# Department of Parks COUNTY OF SAN MATEO

## LETTER OF DECISION

Subject: Certification of Negative Declaration for Crystal Springs Trail South of Highway 92

THREE BEAM BARRIER  
20 LF

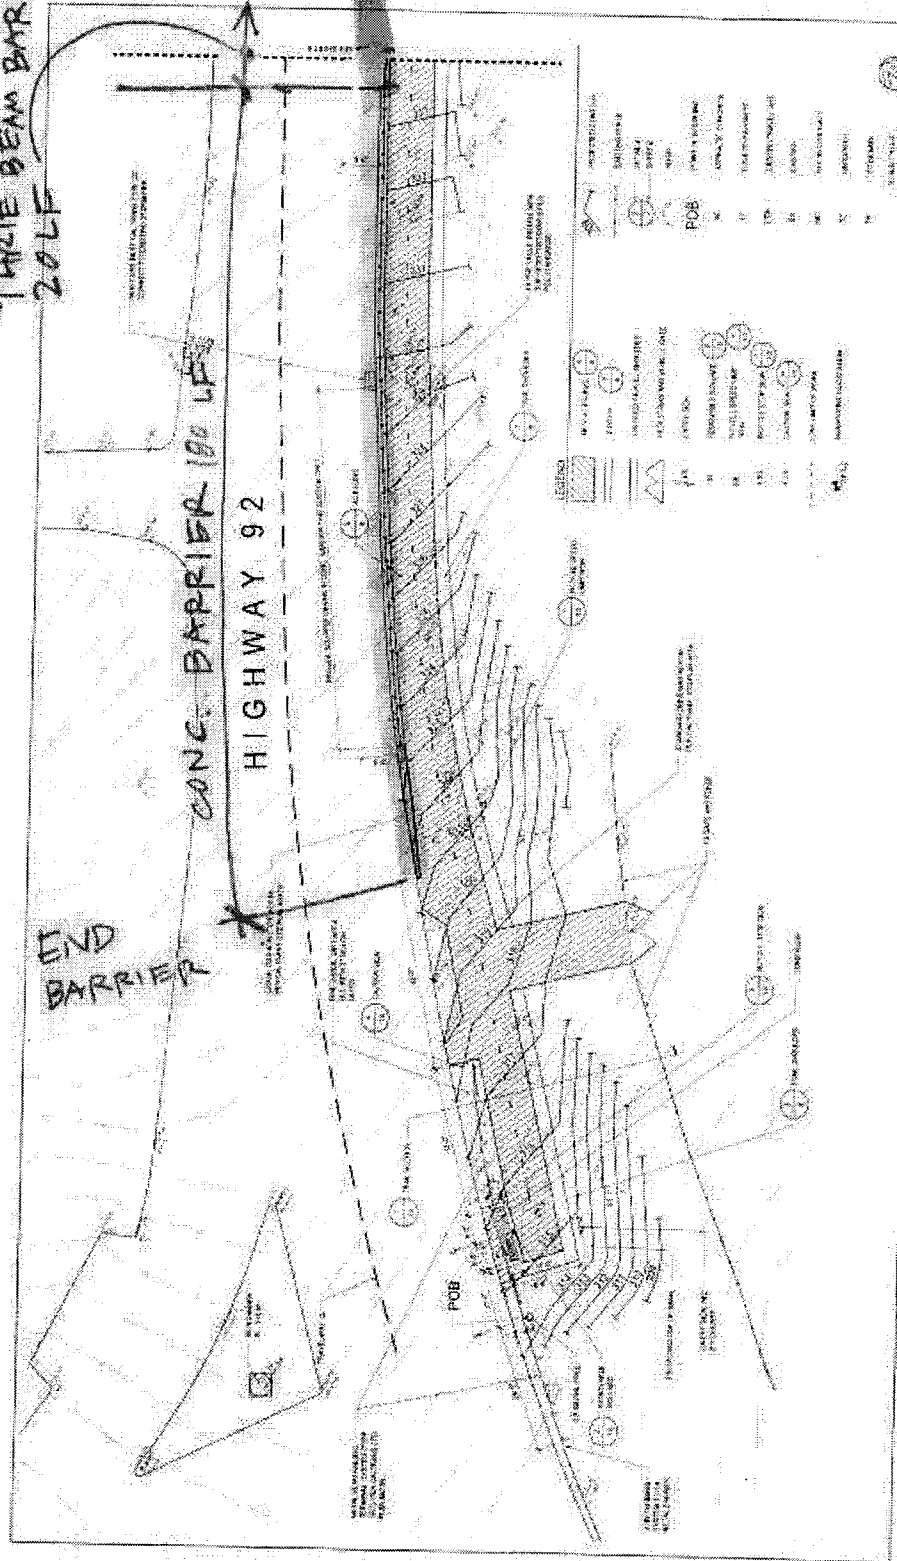
One written comment was received from CalTrans as a result of the State Clearinghouse circulating the Negative Declaration. CalTrans staff requested installing 10 foot long sections of three beam guard rail interspersed with the K-rail barrier at 200 foot intervals throughout the 650 foot stretch of the trail to allow for wildlife movement. Having reviewed proposed alterations to the Design Plans to provide for wildlife movement CalTrans staff concurred the changes made that they had requested, and these changes will be reflected on the Final 100% Design Plans.

I appreciate your assistance on the Cyrstal Springs Trail barrier. I look forward to seeing the revised drawing showing 2 MBG openings.

8. **TRA 2:** The County of San Mateo shall incorporate into its Final Design Plans that the k rail barrier along Highway 92 10 foot long sections of tri-beam guard rail (MBGR) at 200 foot intervals throughout the 650 foot stretch of the trail to allow for wildlife movement. The MBGR will still provide protection and separation of the trail from the travelled way while allowing gaps that would allow small wildlife to cross the roadway relatively unhindered.
